Re: **LETTER OF TRANSMITTAL  
ROOMS TO GO STORE EXPANSION AND REMODEL  
18722 South Dixie Highway  
Cutler Bay, FL 33157  
POST BID ADDENDUM #5**

## **POST BID ADDENDUM NO. FIVE**

Incorporate the following revised CASCO drawings dated 01/29/2024, with revisions including, but not necessarily limited to, those listed below:

**1 FLOOR PLAN**  
A2.0 SCALE: 1/4" = 1'-0"

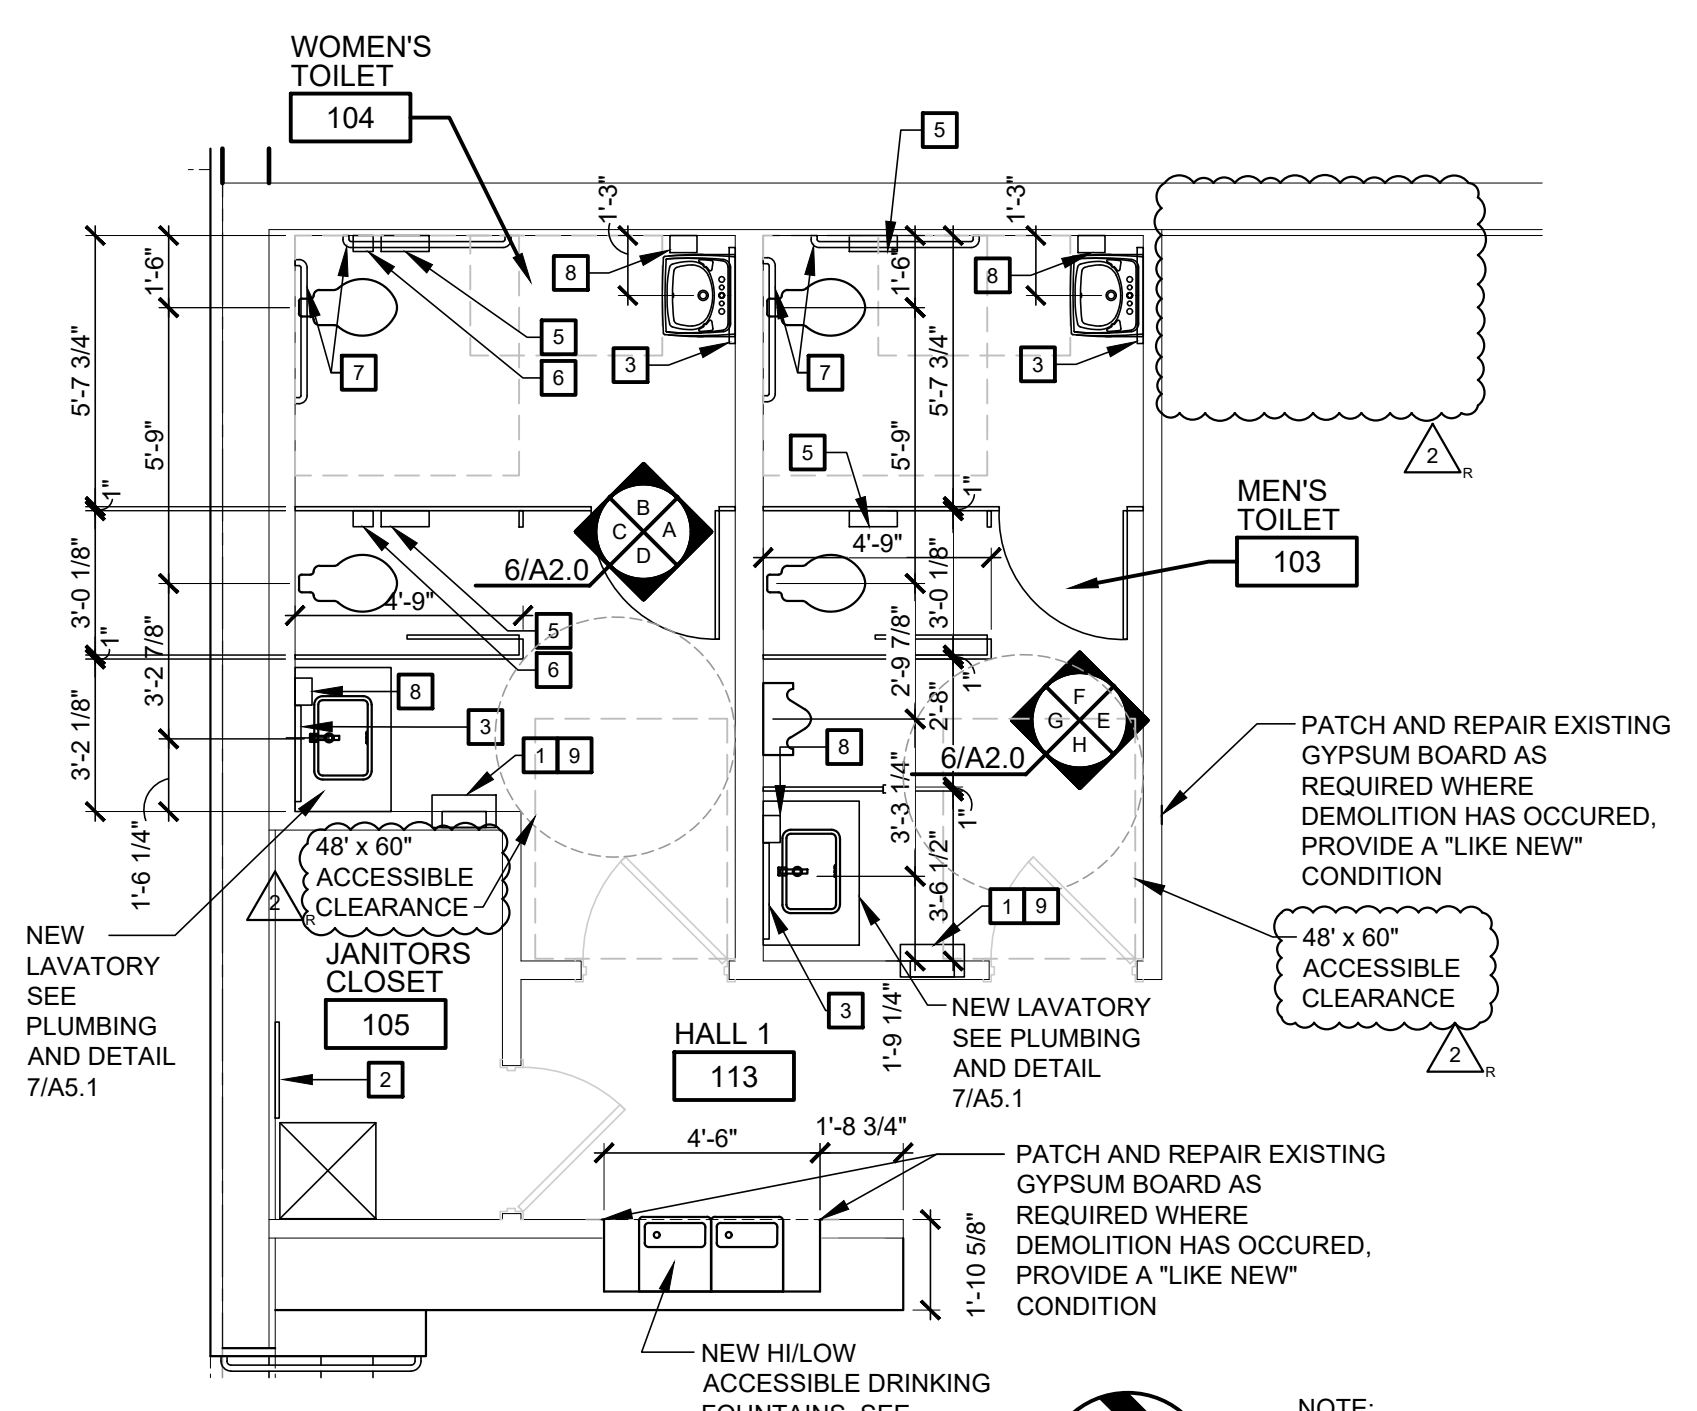
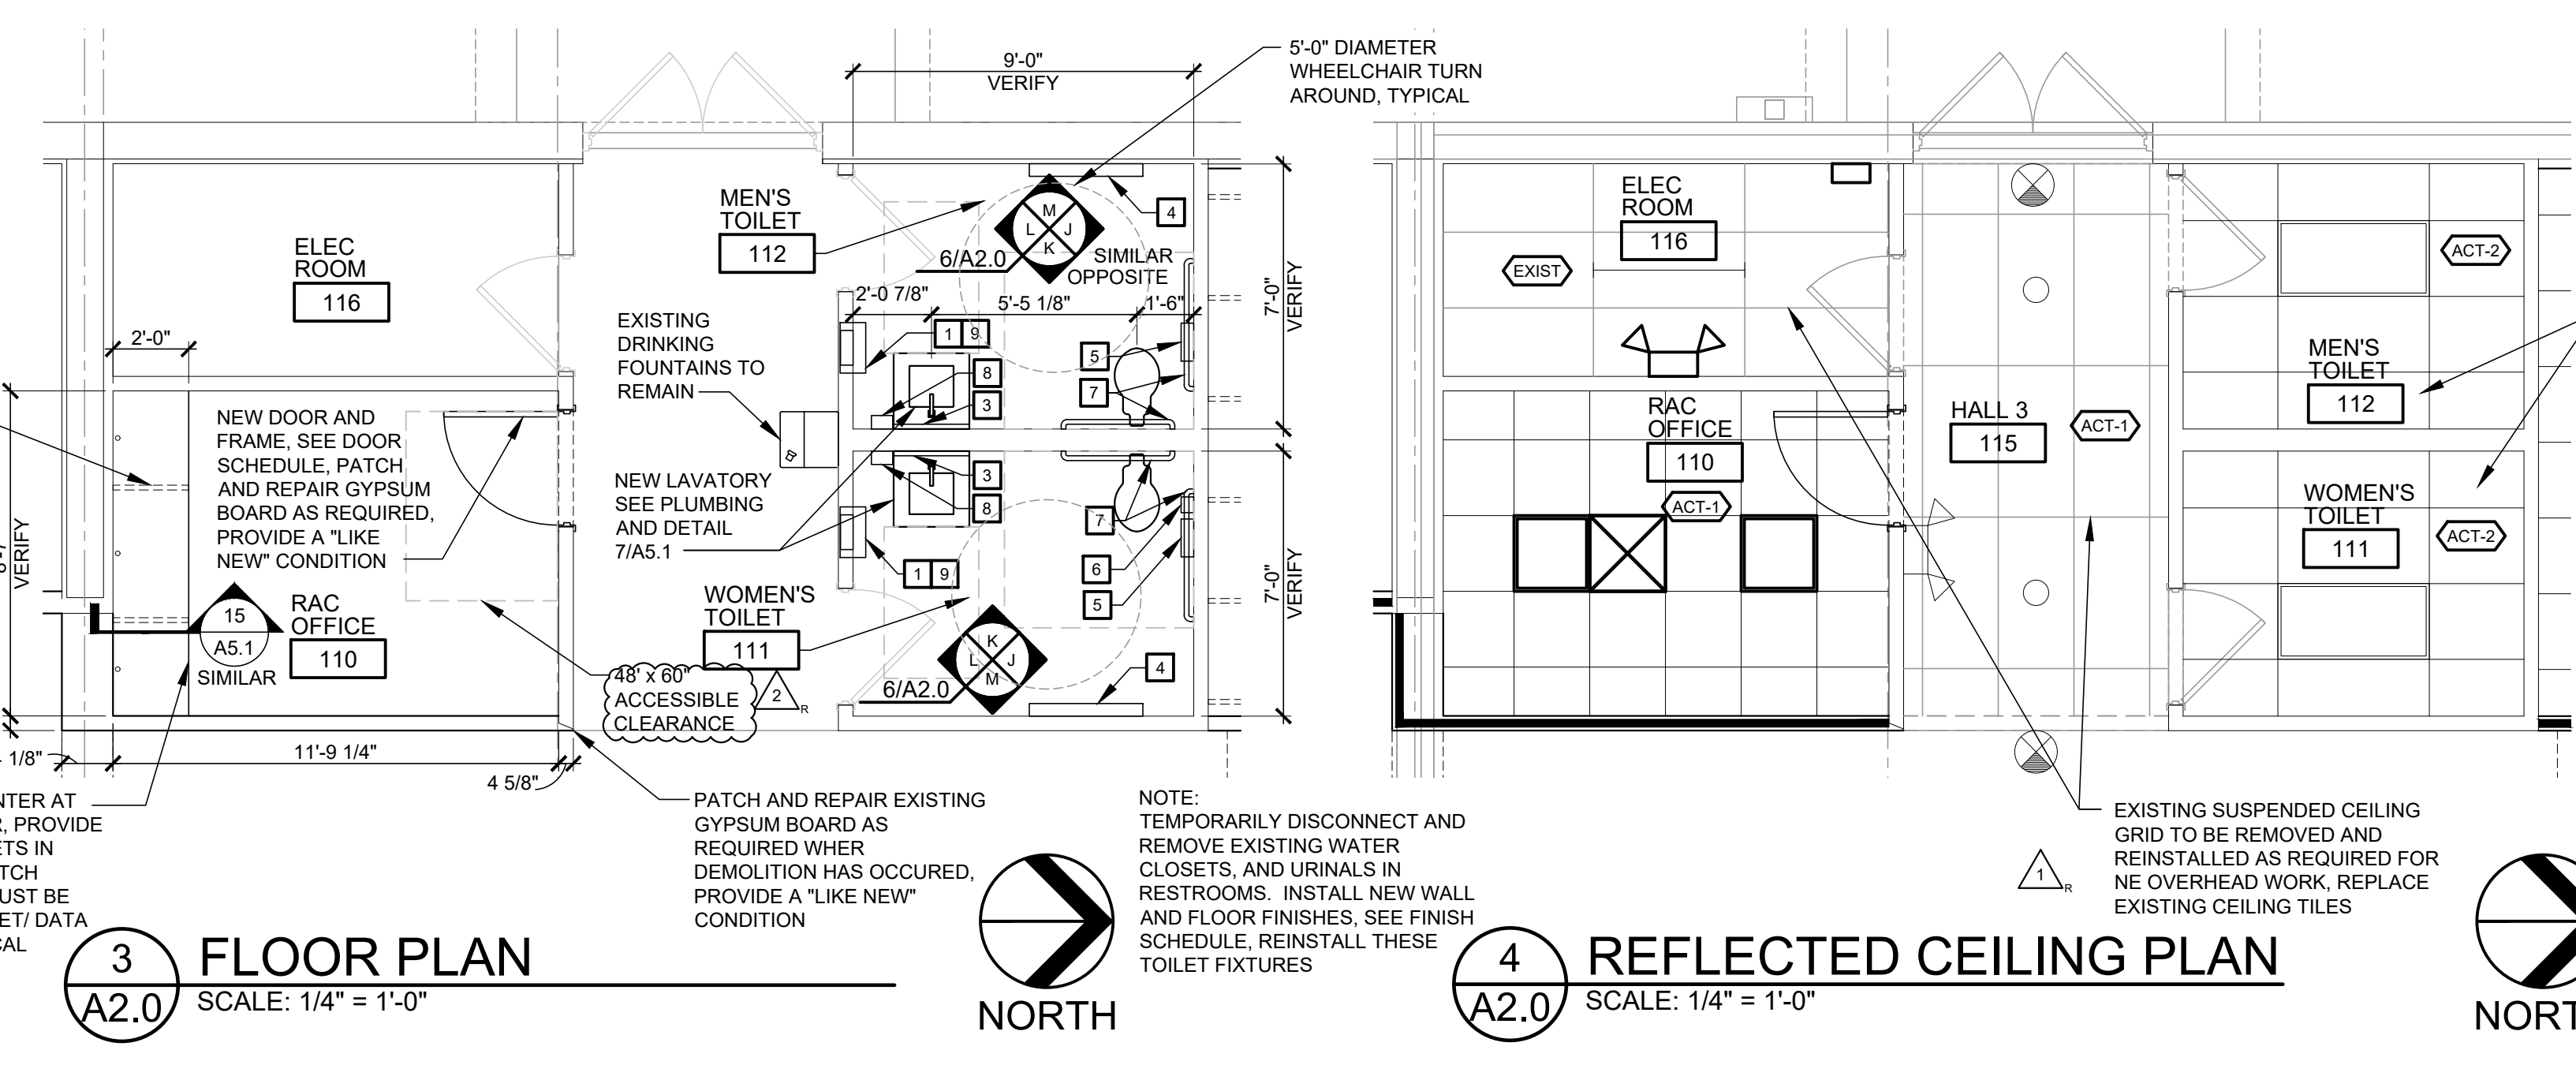
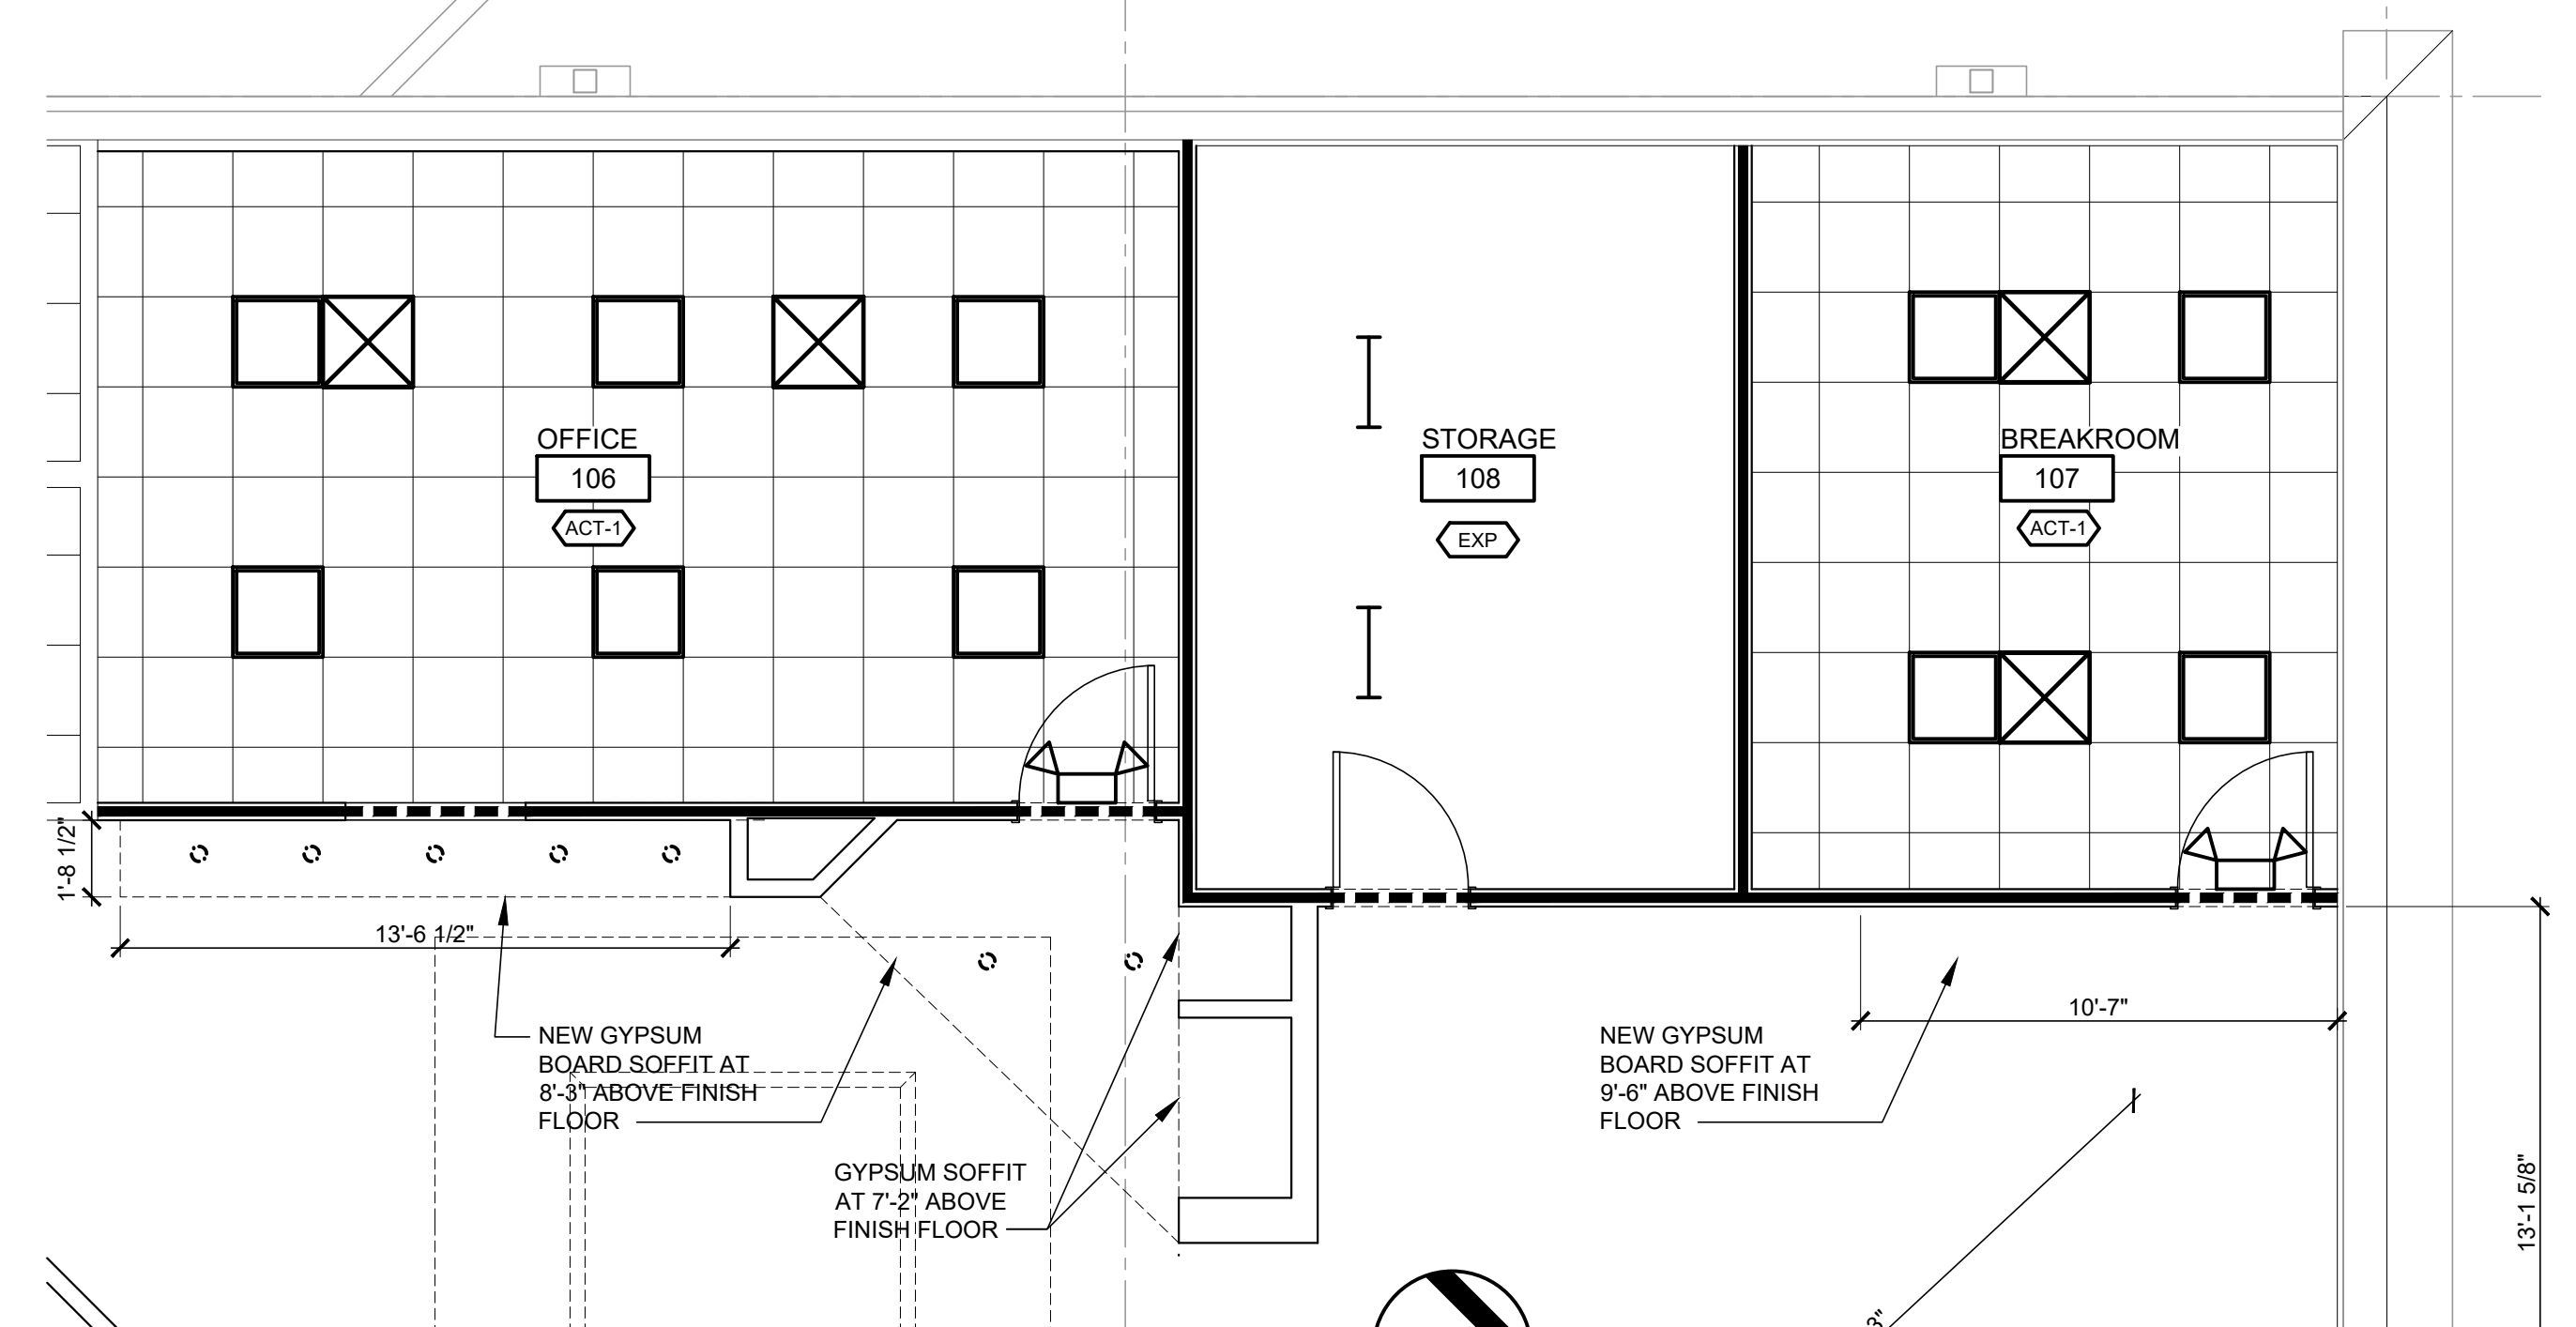
9. Sheet A2.0 – Revision No. 2: Added notes re: 48” X 60” accessible clearance at doors. Added note re: 30” X 48” accessible clearance at Break Room Cabinet. Deleted IDF Room #117.
